EA Project No.: 16-1100

DATE OF ISSUANCE: February 14, 2017

Notice: This addendum is issued to all prospective bidders as an amendment to the Drawings and Project Manual for the Canopy Row. Bidders shall acknowledge this addendum on the Bid Form. All information contained herein shall be fully incorporated into the Contract Documents as though originally included therein.

M131

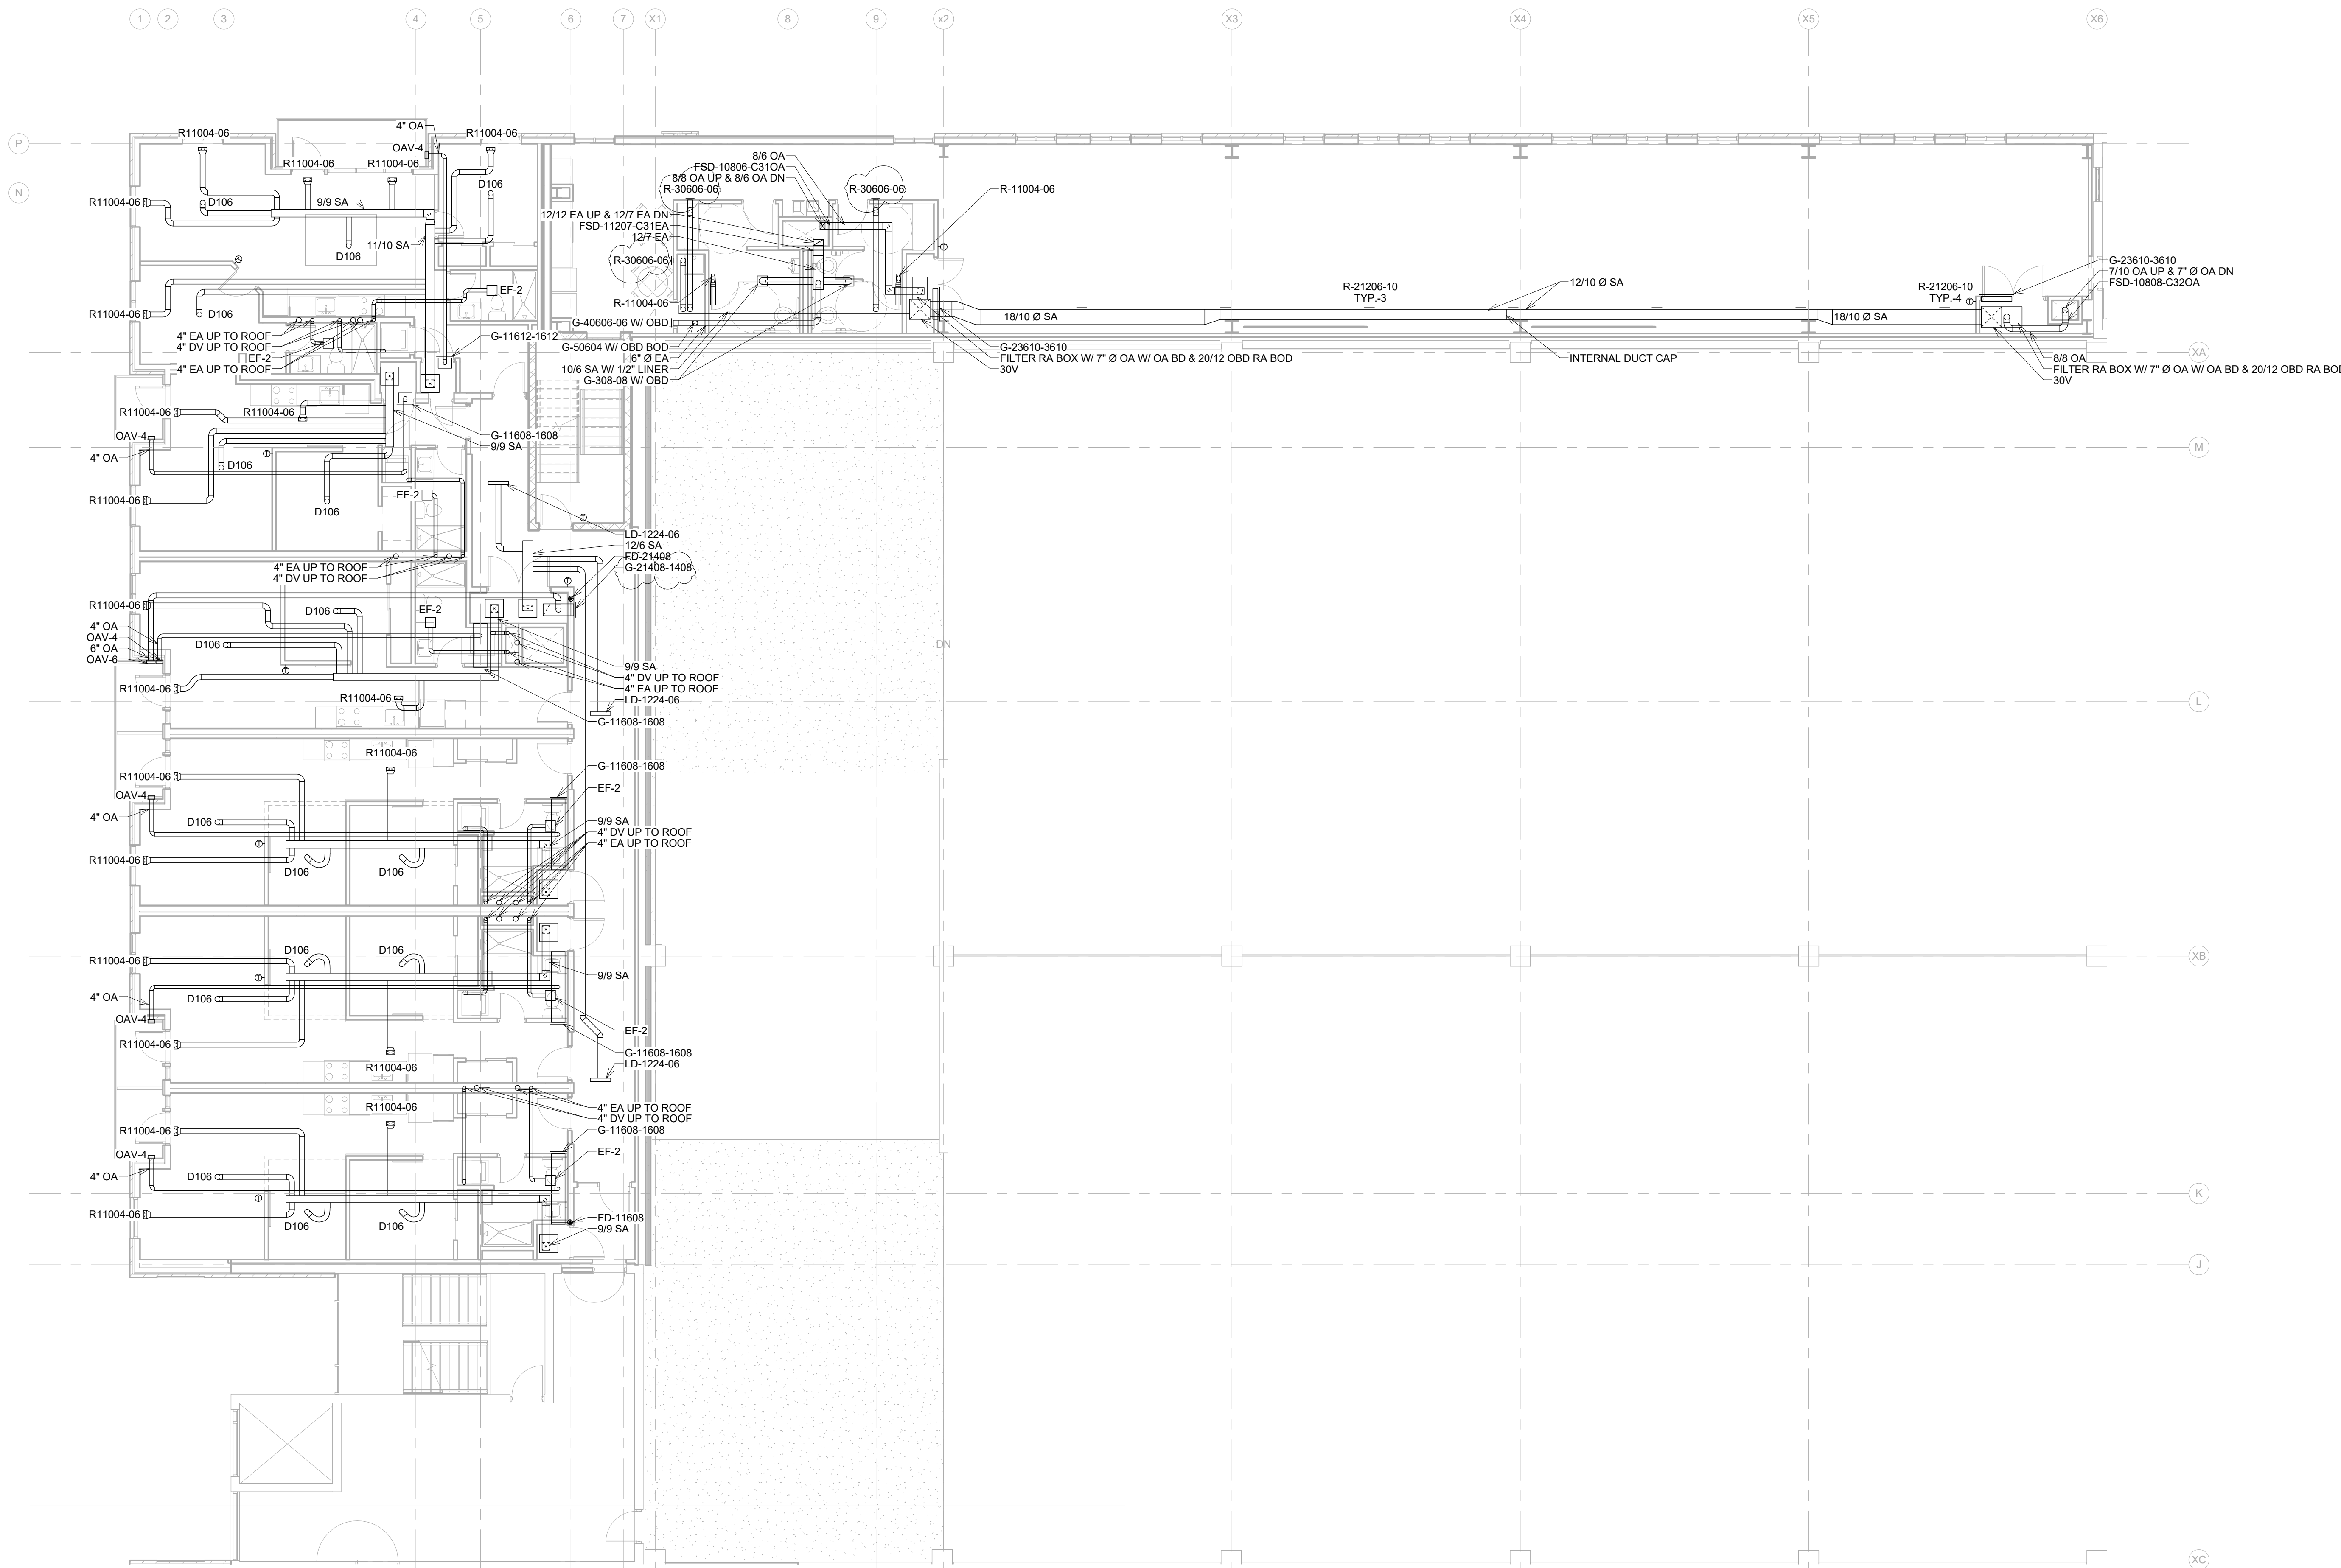
Reference Revised Sheet M131

Mechanical Room A331 change G-11610-1610 to G21610-1610.

M132

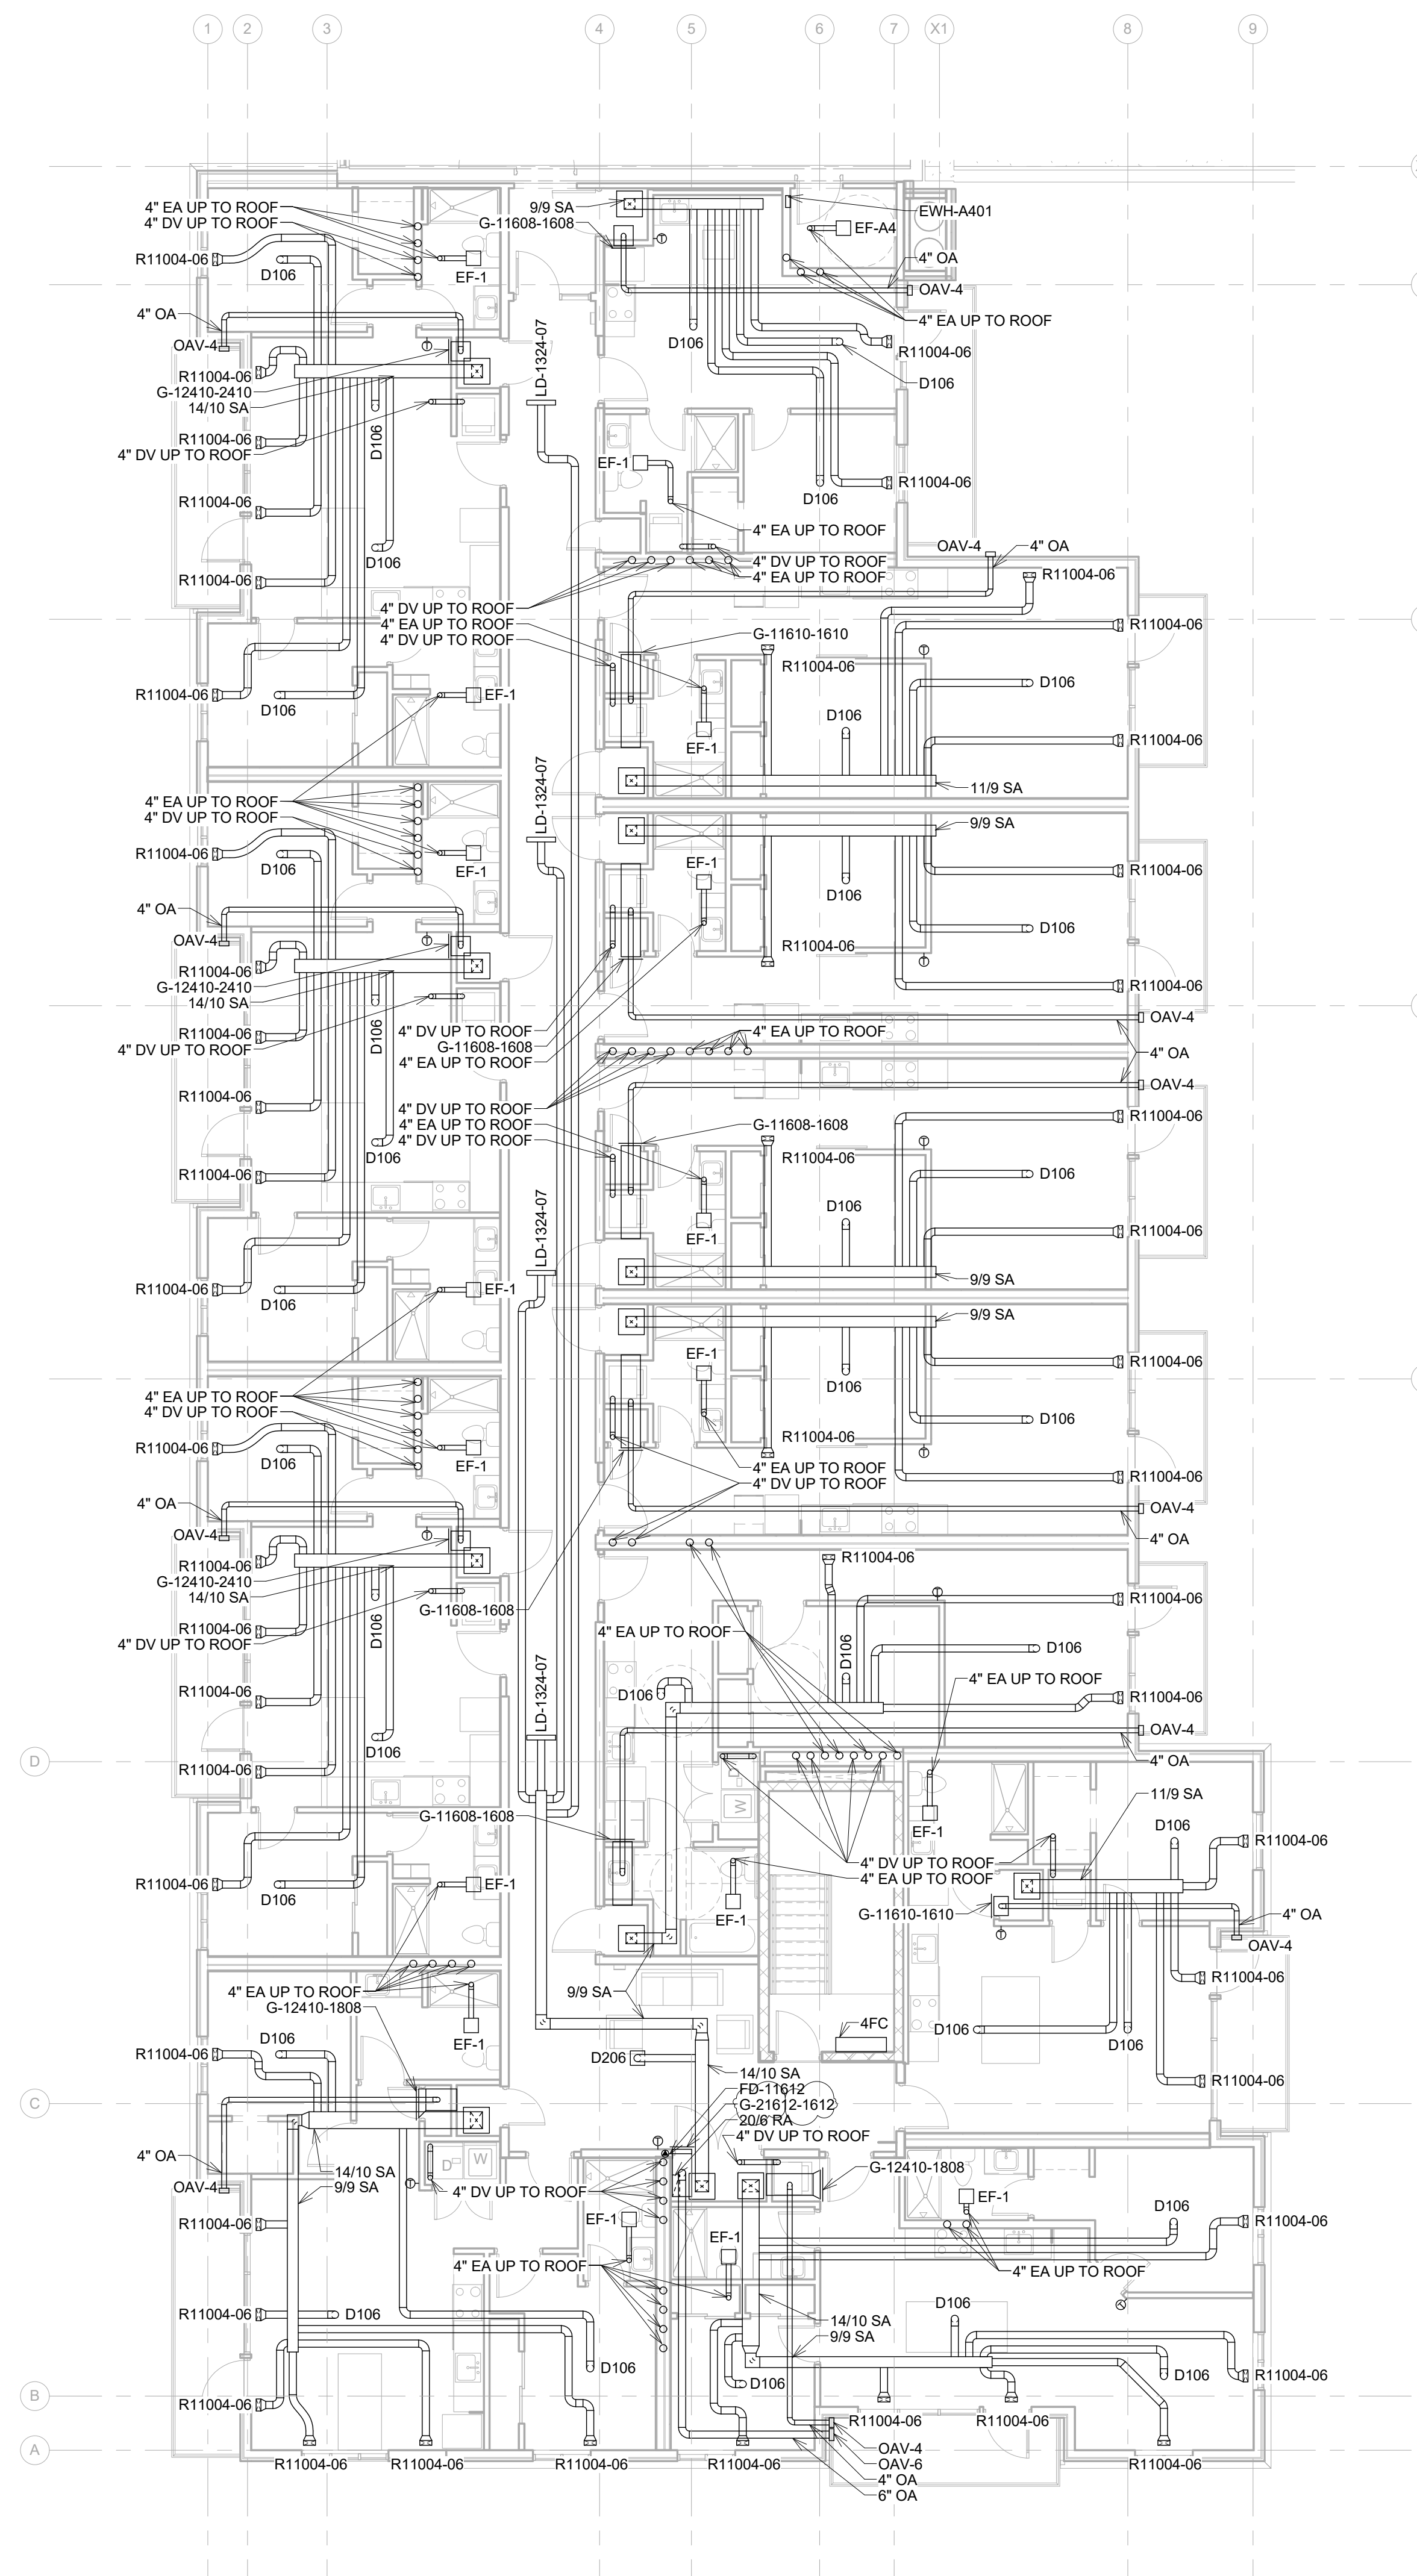
Reference Revised Sheet M132

Mechanical Room B315 change G-11408-1408 to G21408-1408.

Office C300 corridor and kitchen change 3 each R20606-06 to R30606-06.

M141

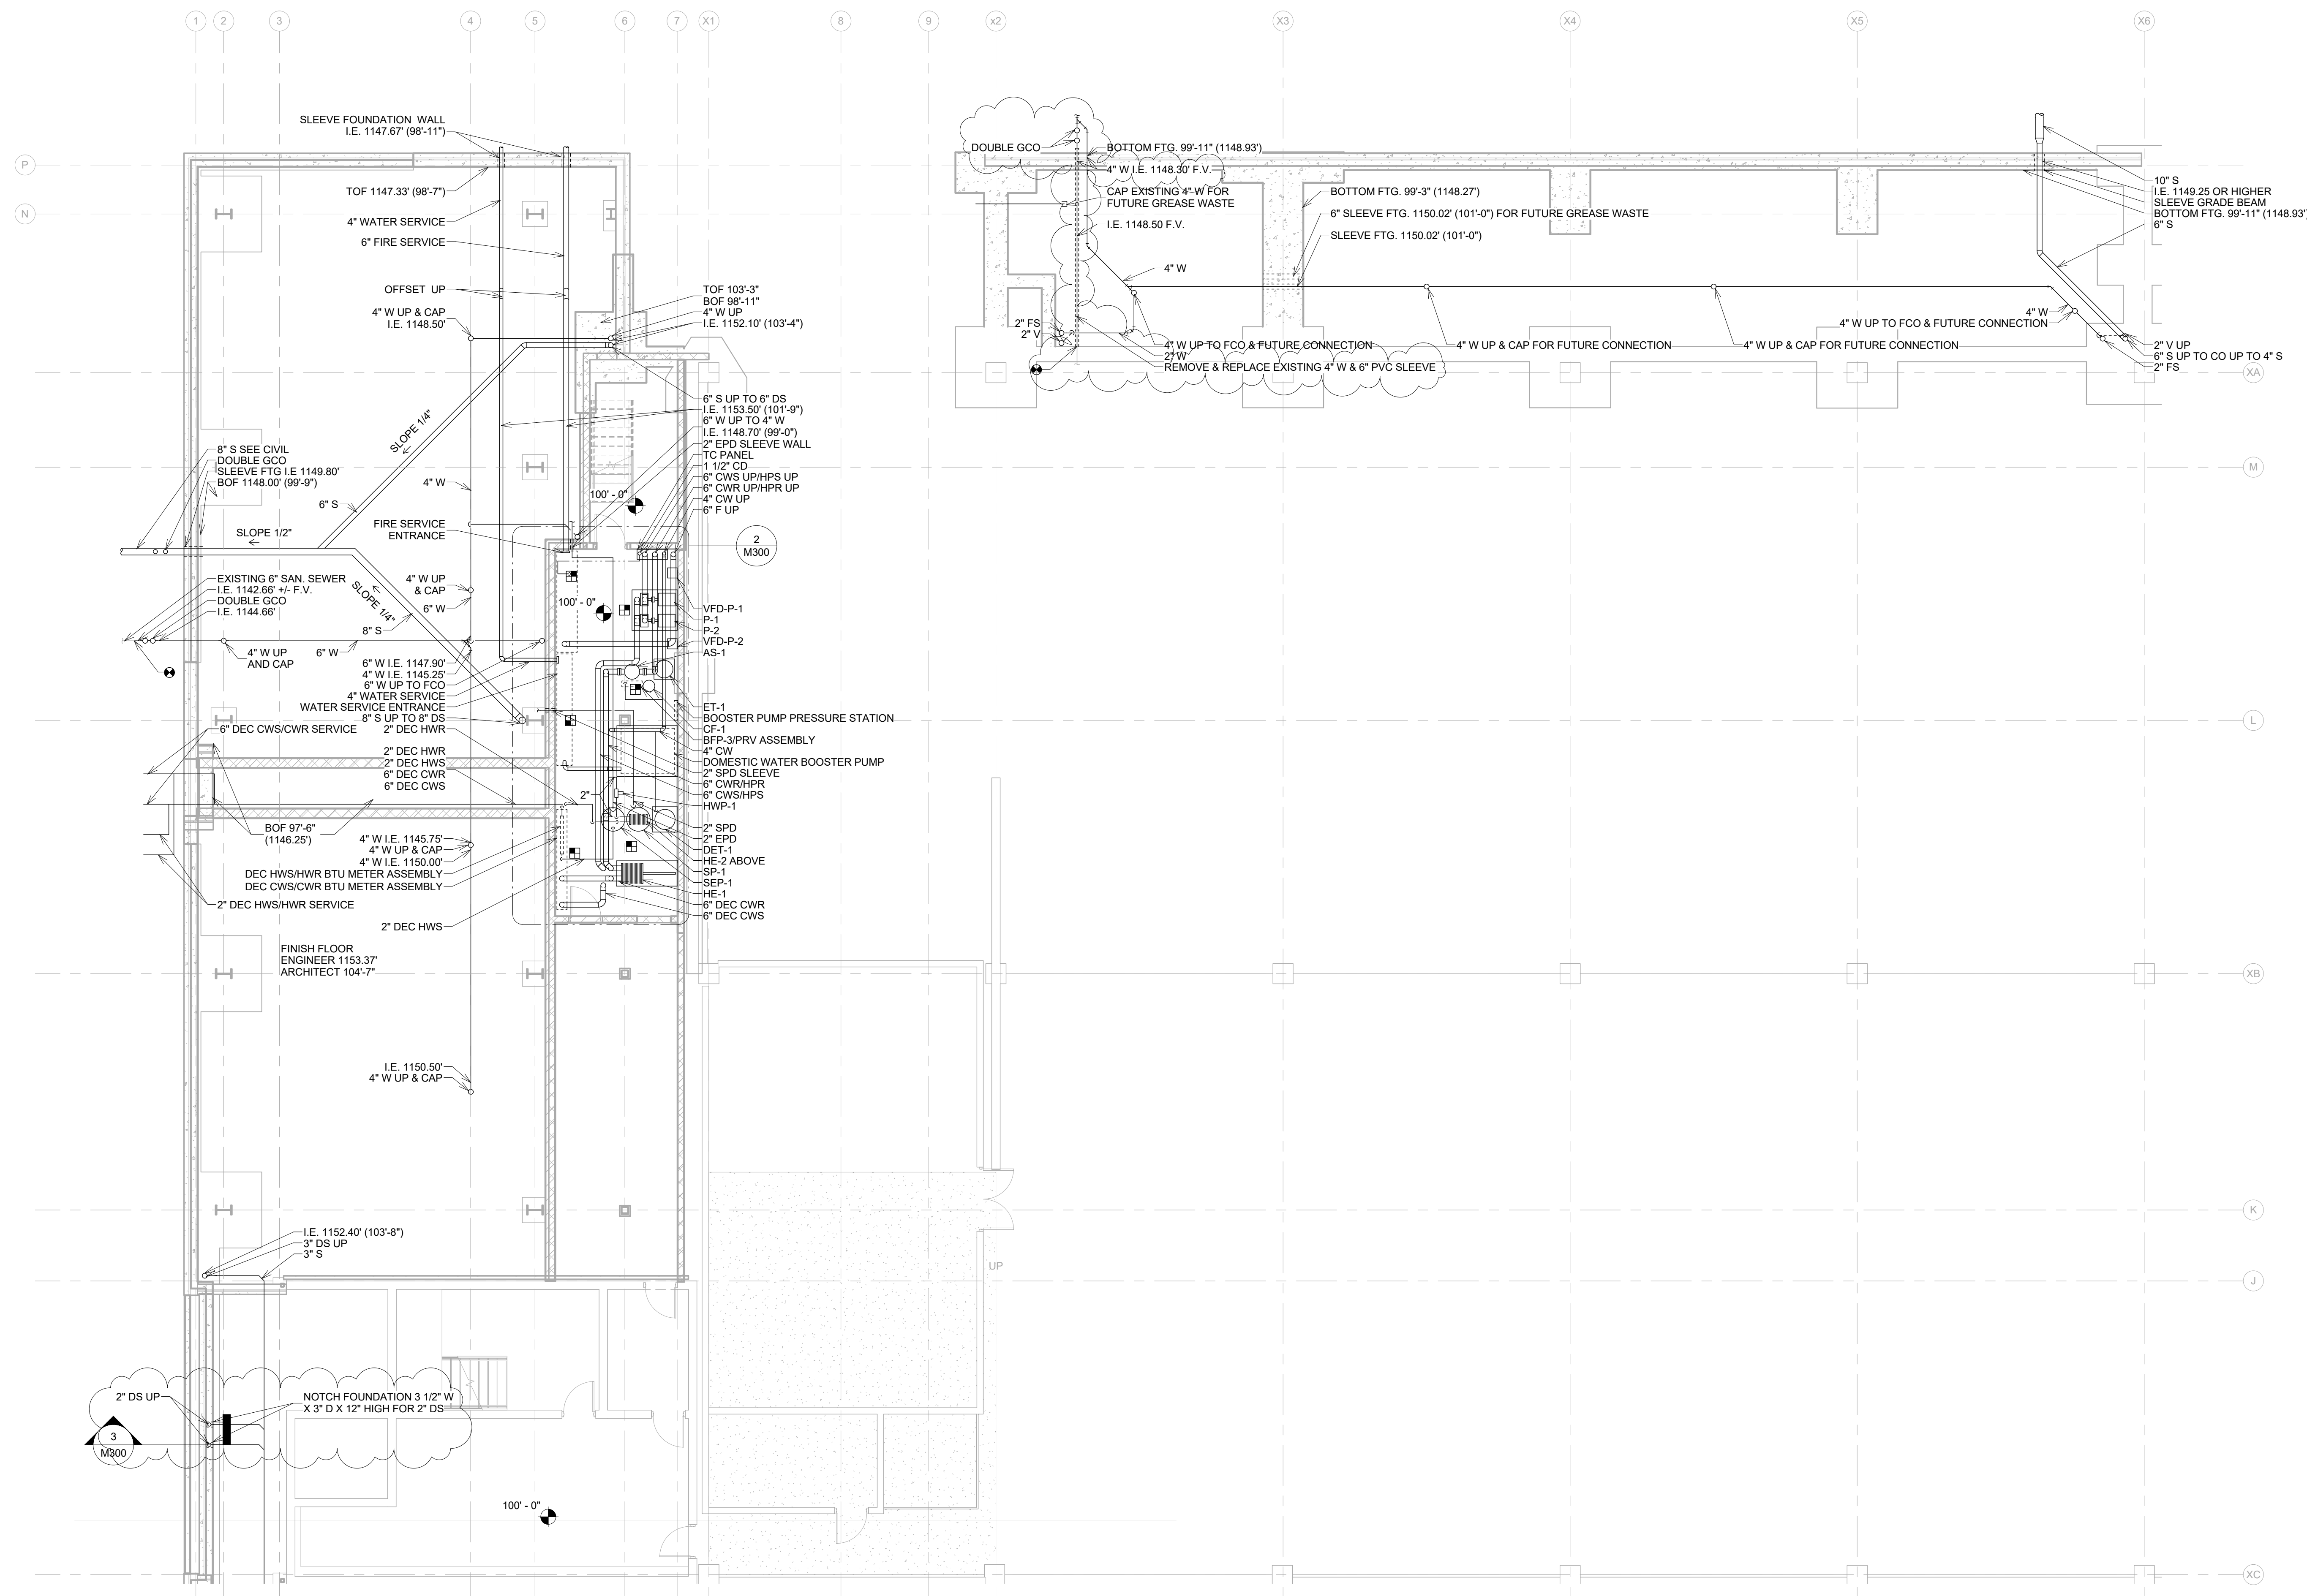
Reference Revised Sheet M141

Mechanical Room A431 change G-11612-1612 to G21612-1612.
